**TOWN OF NEWBURGH  
PLANNING BOARD  
TECHNICAL REVIEW COMMENTS**

**PROJECT NAME:** NPA SITE PLAN  
**PROJECT NO.:** 17-03  
**PROJECT LOCATION:** SECTION 89, BLOCK 1, LOT 80.2 & 80.1  
**REVIEW DATE:** 7 AUGUST 2024  
**MEETING DATE:** 15 AUGUST 2024  
**PROJECT REPRESENTATIVE:** ZEN DESIGN CONSULTANTS

<b>ENGINEER</b> WILLIAM J. MOREAU		<b>PROPOSED SITE PLAN</b> NEWBURGH PARK ASSOCIATES, INC. <b>PROPOSED SITE PLAN</b> SBL: 89-1-(80.1 & 80.2) TOWN OF NEWBURGH, ORANGE COUNTY, NY	
DATE	SCALE	JOB NUMBER	SHEET NUMBER
7/7/2016	1"=30'	15-008-PMU	2 OF 5

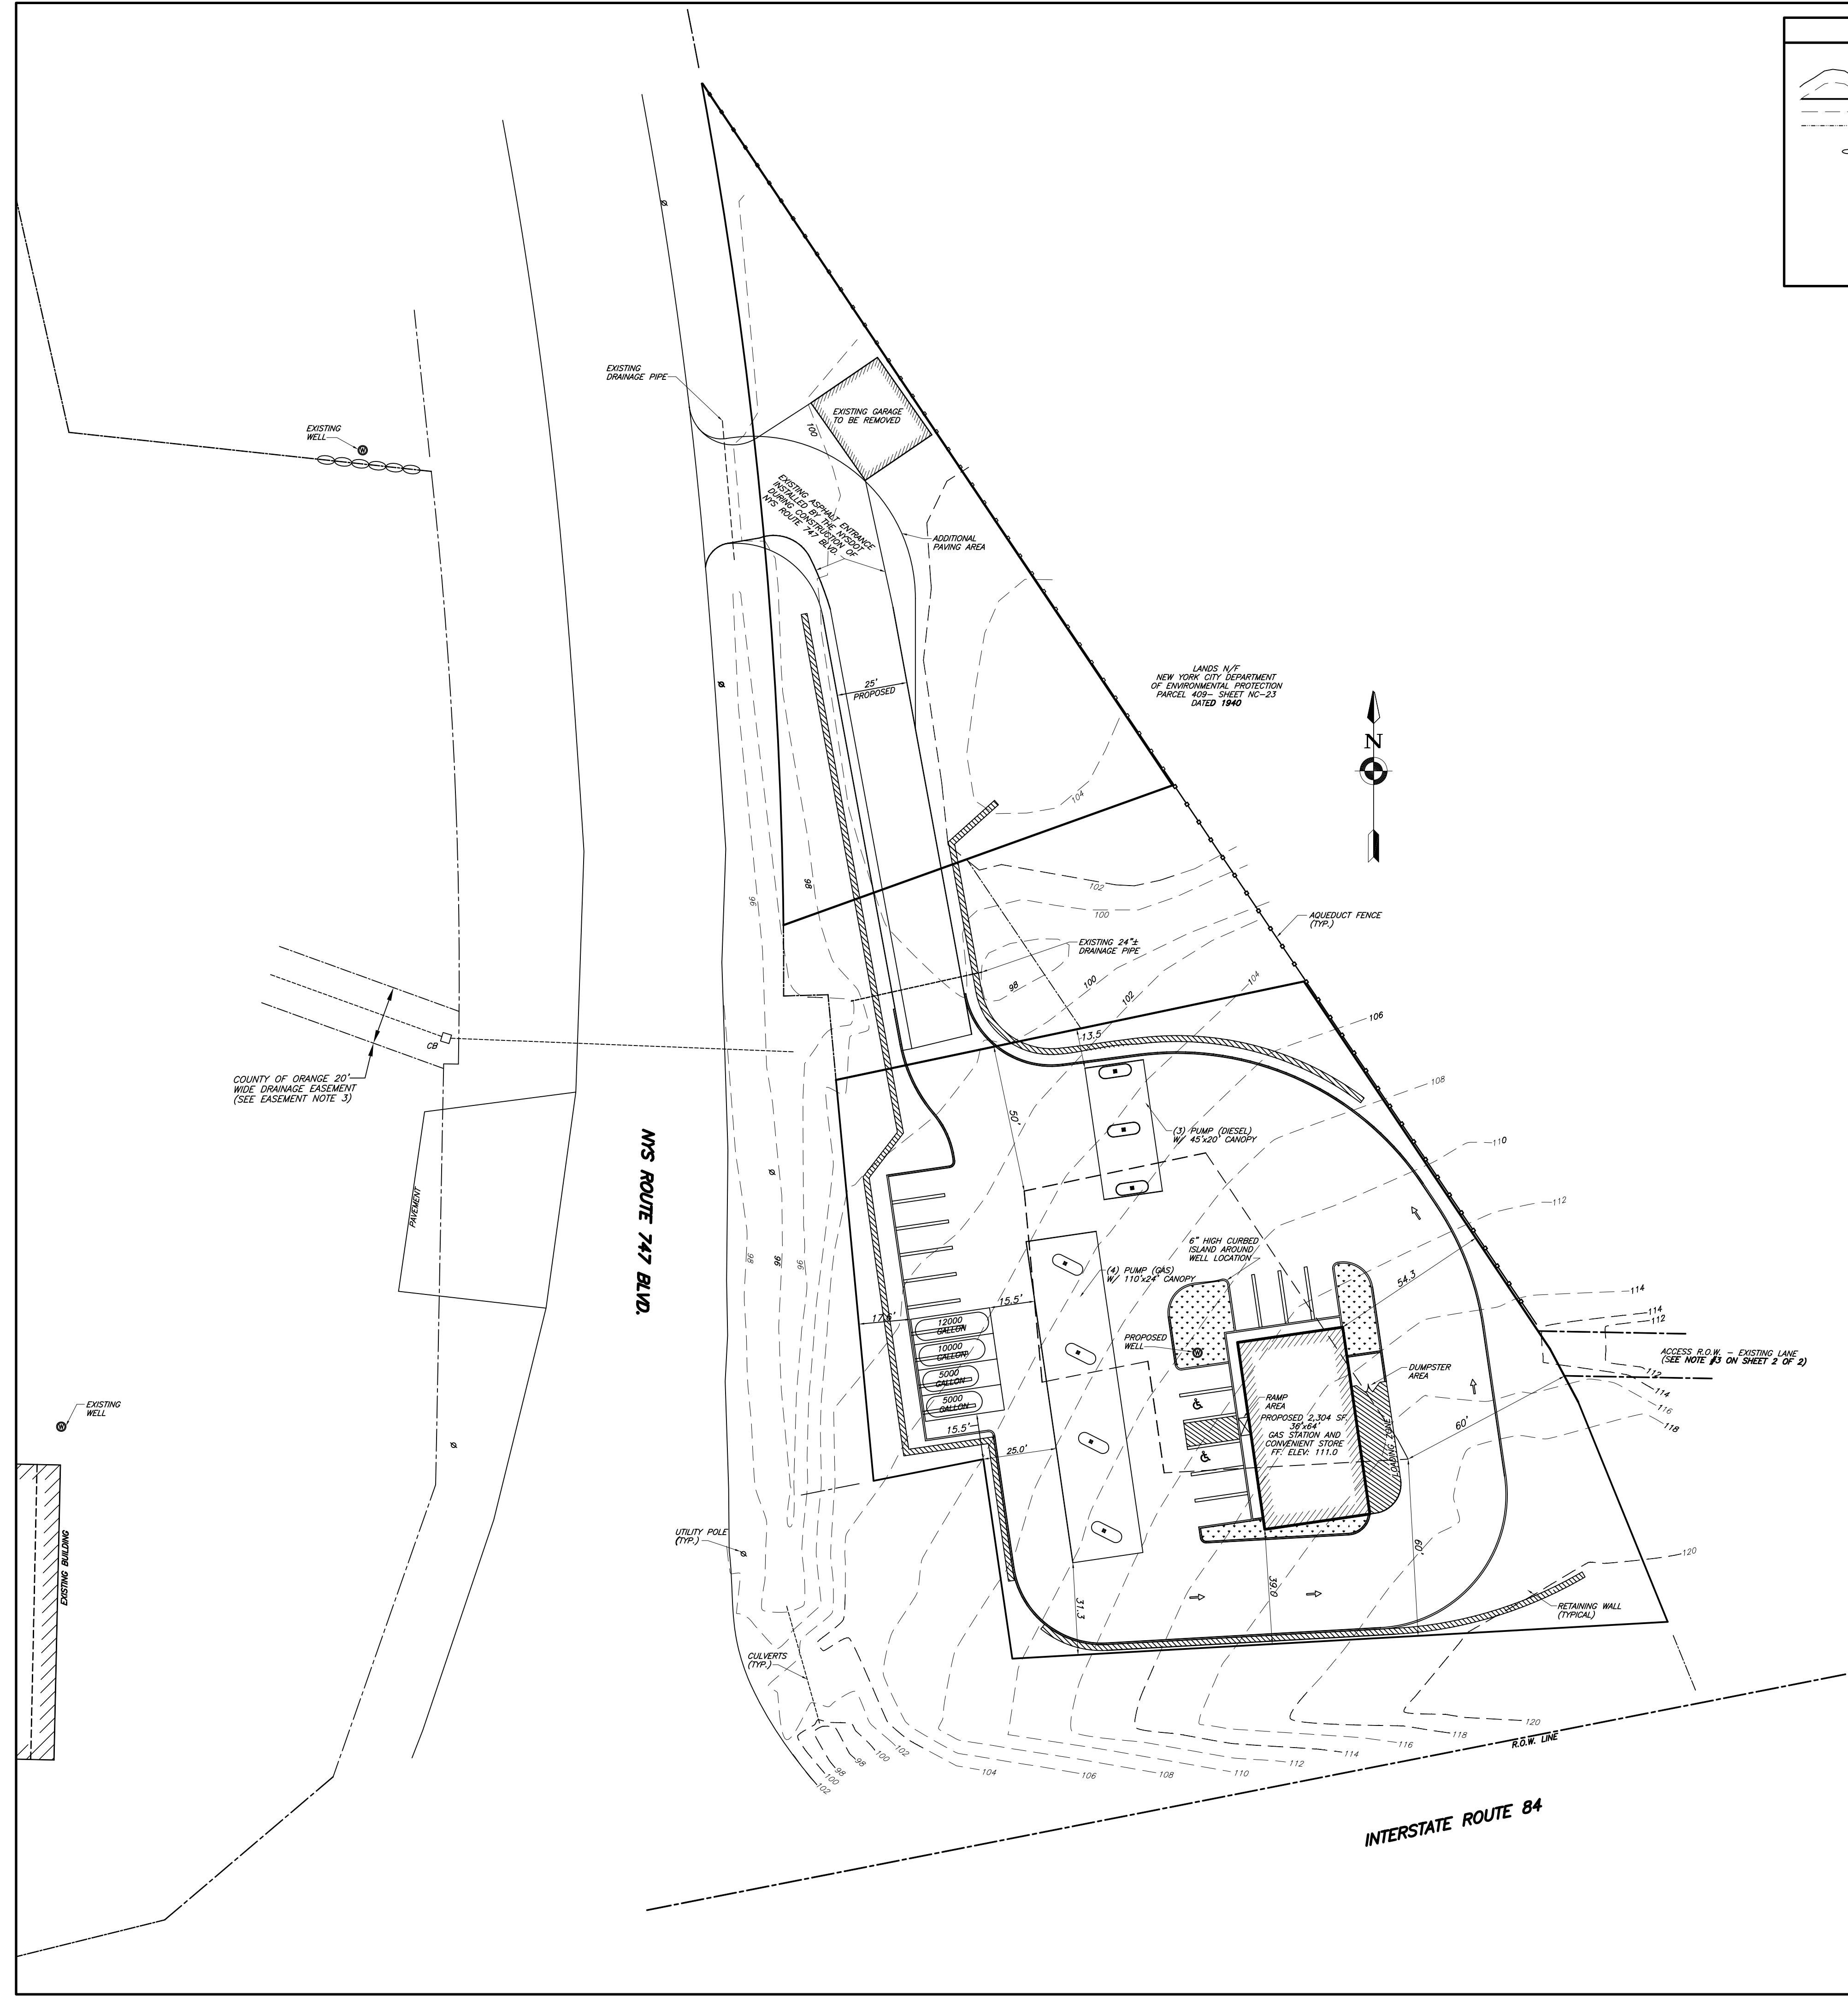
12. Access right-of-way note states “see Note 3 on Sheet 2 of 2”. Plan set contains more than 2 sheets.
13. A site lighting plan should be provided.

<b>ENGINEER</b> WILLIAM J. MOREAU		<b>PROPOSED SITE PLAN</b> NEWBURGH PARK ASSOCIATES, INC. <b>DRAINAGE &amp; GRADING</b> SBL: 89-1-(80.1 & 80.2) TOWN OF NEWBURGH, ORANGE COUNTY, NY	
DATE	SCALE	JOB NUMBER	SHEET NUMBER
7/7/2016	1"=30'	15-008-PMU	3 OF 5

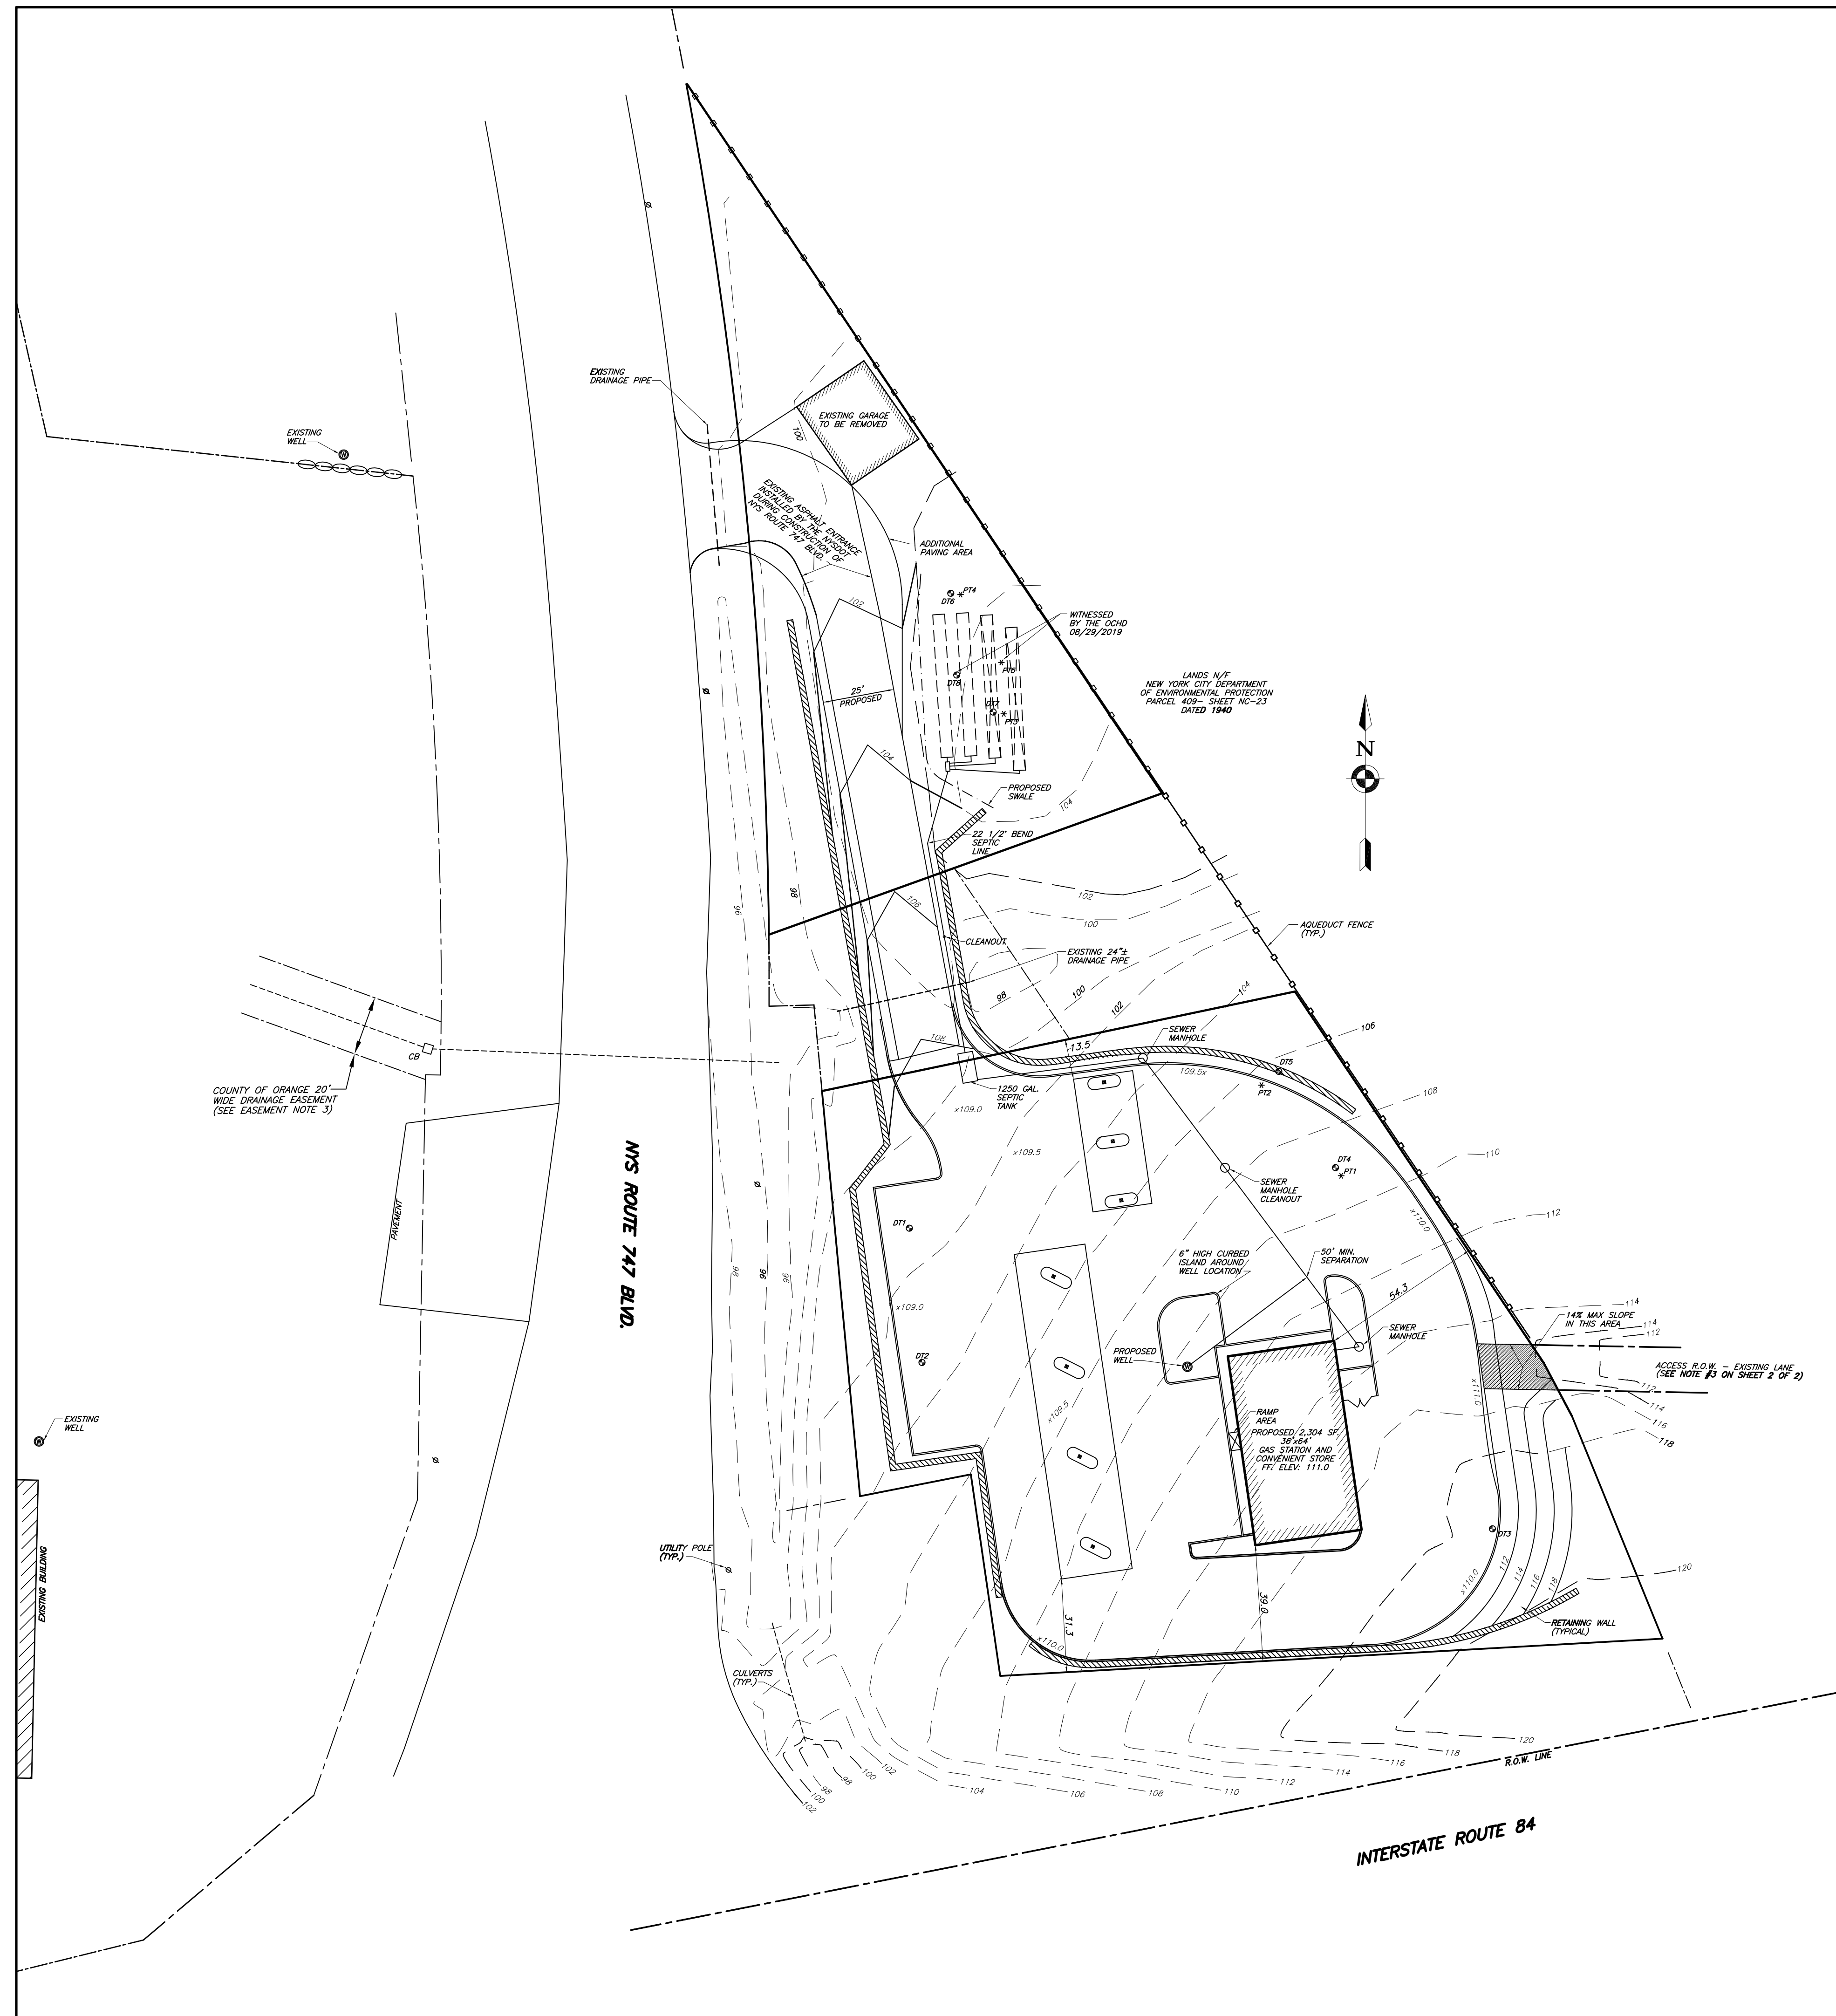
14. Sheet 3 of 5 is identified as a grading and drainage plan. The proposed drainage infrastructure is not depicted on this plan. Height of all the retaining walls (top and bottom wall) should be depicted on the grading plan.
15. A landscape plan must be incorporated into the plan set.
16. The project will be subject to landscape and stormwater security and inspection fees.
17. Detail designs for retaining walls should be added to the plans including any fencing and guide rail requirements.
18. Coordination of the outlet control structure with inverts on the plans should be undertaken.
19. Landscape plan should be forwarded to the Town's Landscape Architect Consultant, Karen Arent for review.
